LIGO 1U Chassis		
		Front and Rear Panel		
8 Aug 2006	SIZE B	FSCM NO.	DWG NO. D060281-A	REV
R. Abbott	SCALE		SHEET	1 of 1

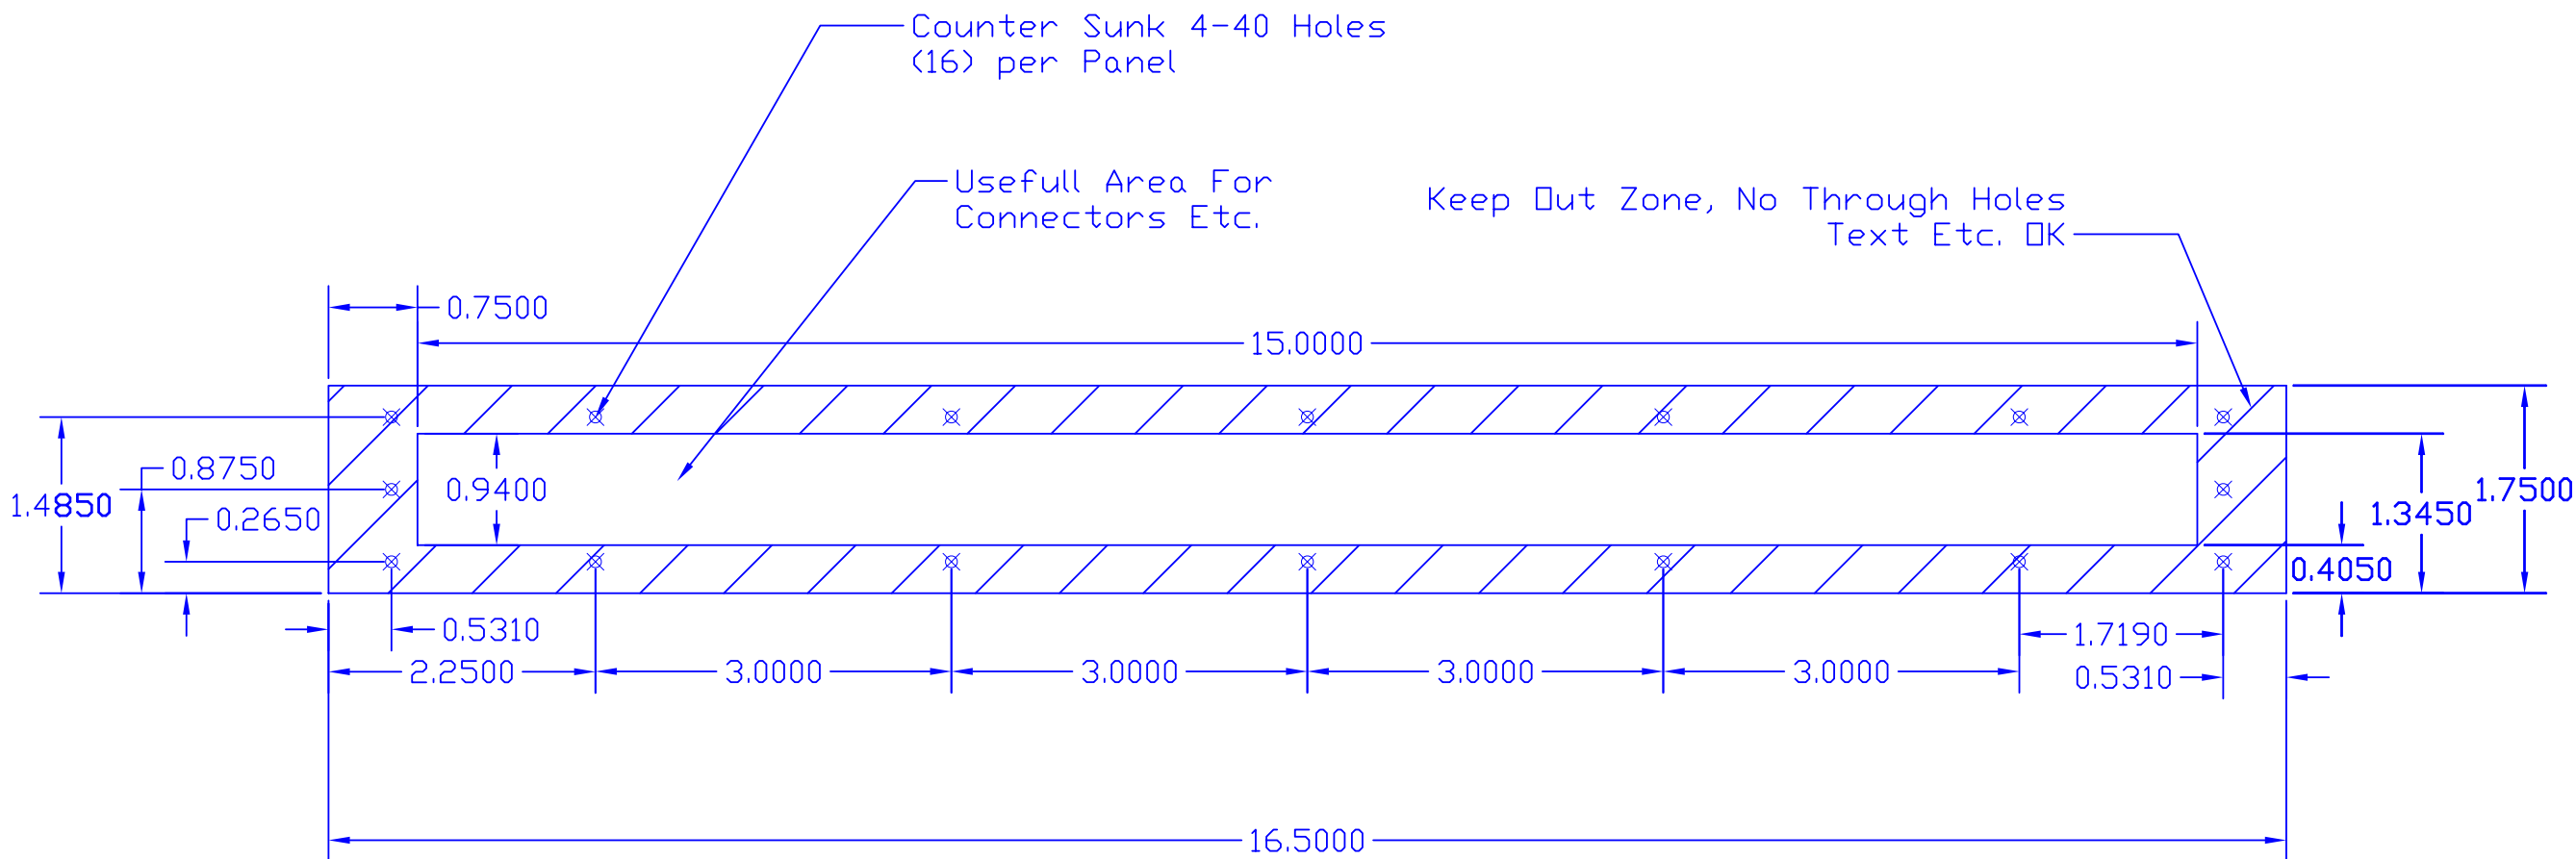
Revision A lowers the vertical dimension from 1.8 inches to 1.75 inches to conform to the 1U standard
